ZONING CHANGE REVIEW SHEET

CASE: C14-2010- 0204 – Riverside Gardens

ADDRESS: 6716 East Riverside Drive

117 SINGLE FAMILY LOTS 40' x 110' TYP

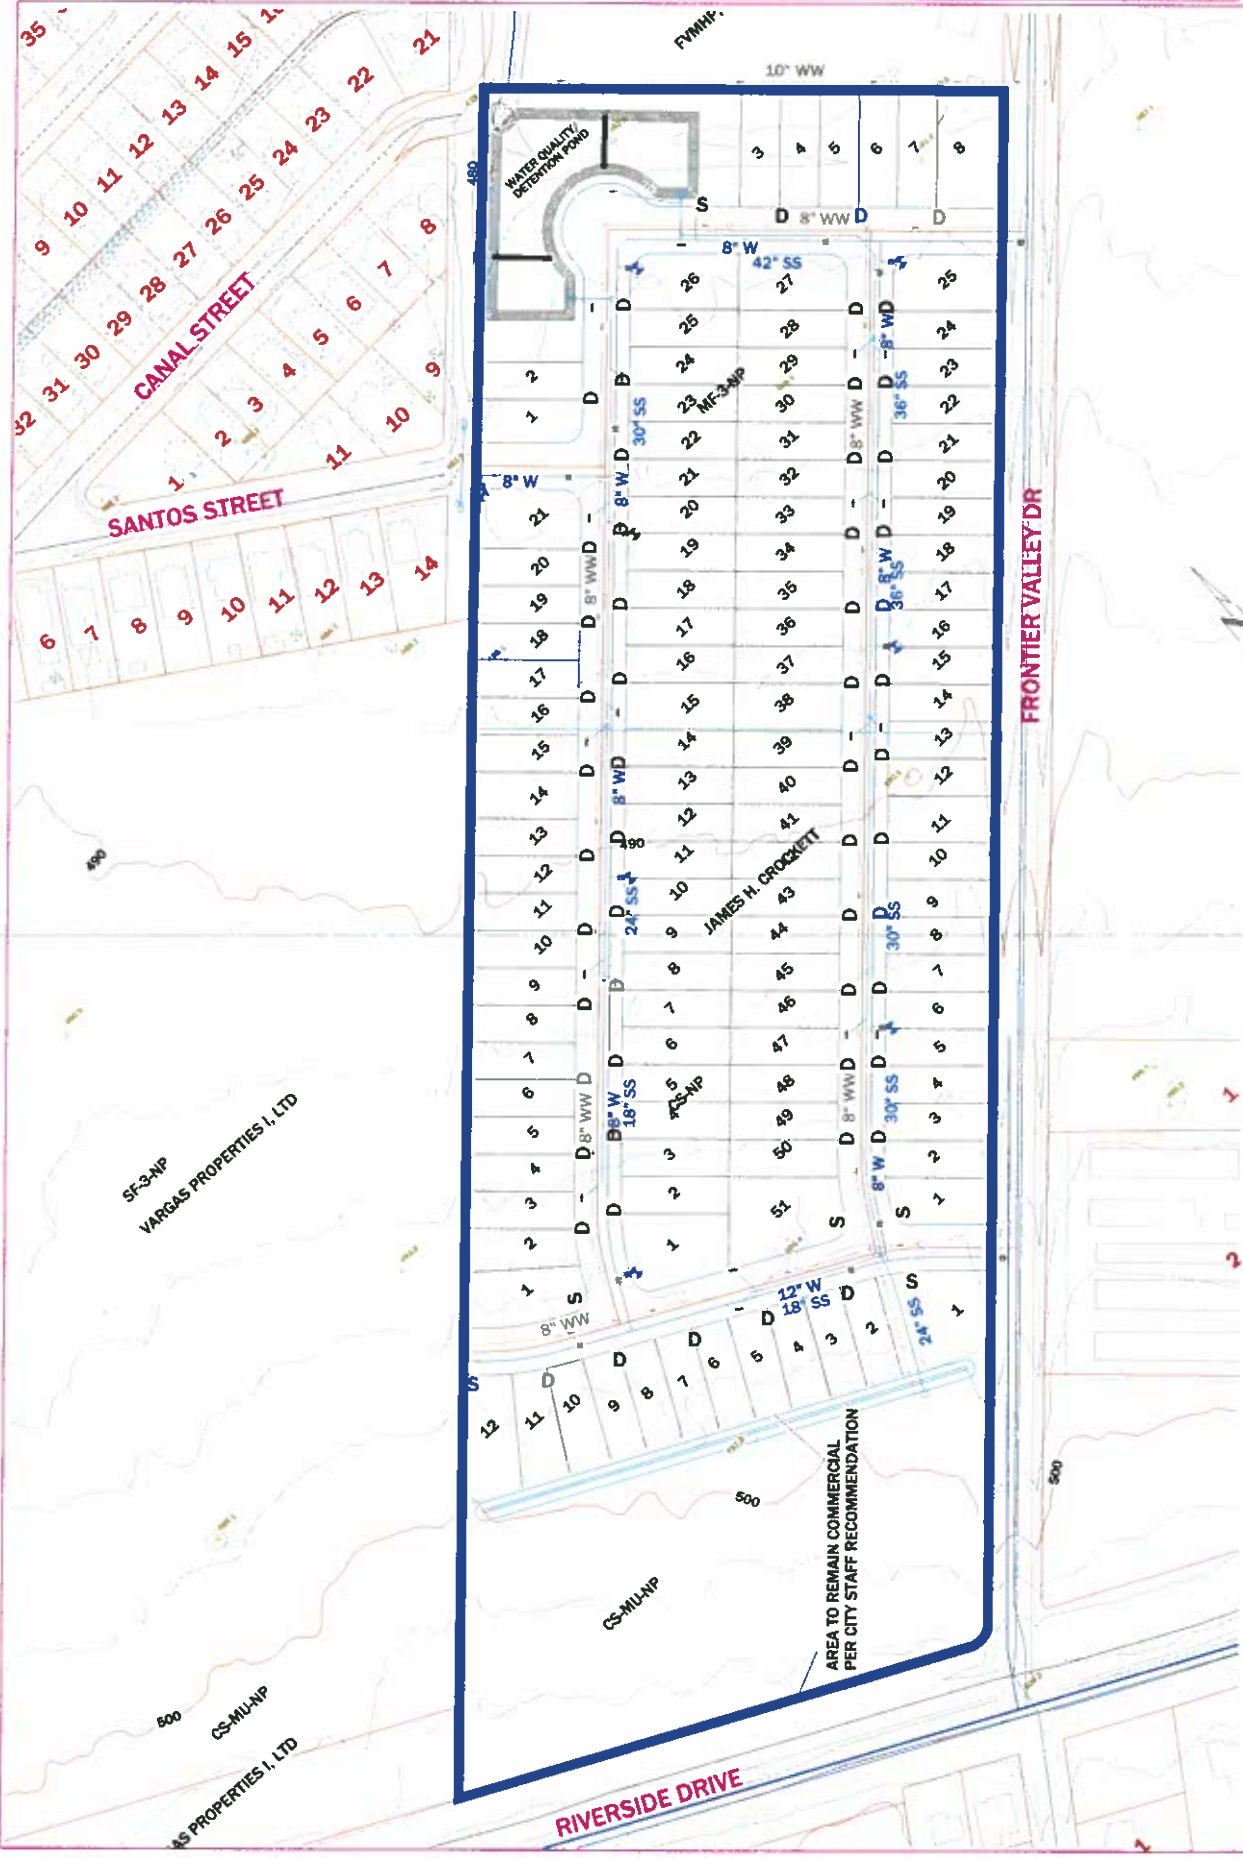
From reading the attachments for C14-2010-0204, I see that the applicant has claimed that a Traffic Impact Analysis is not required. However, we do know that the addition of 117 lots with access only to Frontier Valley Drive is going to increase traffic on Frontier Valley Drive in two directions:

With 117 home lots, it is not unreasonable to assume that this will generate at least 300 vehicle trips per day. $117 \text{ homes} \times 2 \text{ drivers} \times 2 \text{ trips} = 468 \text{ vehicle trips}$

Questions: Shouldn't a Neighborhood Traffic Analysis be conducted? If not, is there another way to address community concerns regarding this expected increase in traffic?

Question: With an entry and exit only on Frontier Valley Drive, the Riverside Gardens plan does not enhance community access and connectivity. How can the plan be revised so that it does?

Question: The Riverside Gardens plan doesn't improve traffic flow throughout the neighborhood. It simply adds more traffic. How can the plan be revised to improve traffic flow?

Question: The Riverside Gardens does not seem to comply with Action 46. How can the plan be revised so that it does?

Question: With entry and exit only on Frontier Valley Drive, it does appear that the planned street network will consider connectivity for pedestrians and other modes of transportation expect to only get to Frontier Valley Drive. How can the plan be revised with the consideration of this connectivity goal stated in Action 47?

The now empty lot where Riverside Gardens will be built does an excellent job of absorbing rainwater. With the addition of 117 40 ft x 120 ft lots (about 13 acres), along with the street infrastructure (unknown acres), there is going to be a considerable increase in the amount of impervious cover and in the volume of storm water that flows downstream.

We downstream residents are very concerned that the storm water retention ponds need to be sized to be more than adequate to handle future storm events.

- Will Watershed Protection be involved any modeling or analysis to size the retention ponds and determine the best management practices for this site?
- Will storm water from the retention pond flow directly into the creek channels, or will that water enter into a storm drain and be carried underground and exit into the creek farther downstream?

I have been working with staff to address your questions. The only applicable traffic question in regards to the current application and staff review is the requirement for a Neighborhood Traffic Analysis. According to the reviewer, Sangeeta Jain, an NTA was not required. I cannot elaborate on the basis of that determination and would defer to her for a more detailed response. The remainder of the traffic questions refer to how the applicant could revise his subdivision plan to improve traffic and street networks. These are issues that must be addressed by the applicant at subsequent subdivision or site planning stages.

The drainage issues will be addressed by the applicant at the site planning process. The project will be required to meet the provisions of the city code. Without further information given to Watershed staff via a site plan, staff cannot make a determination on drainage patterns and retention ponds.
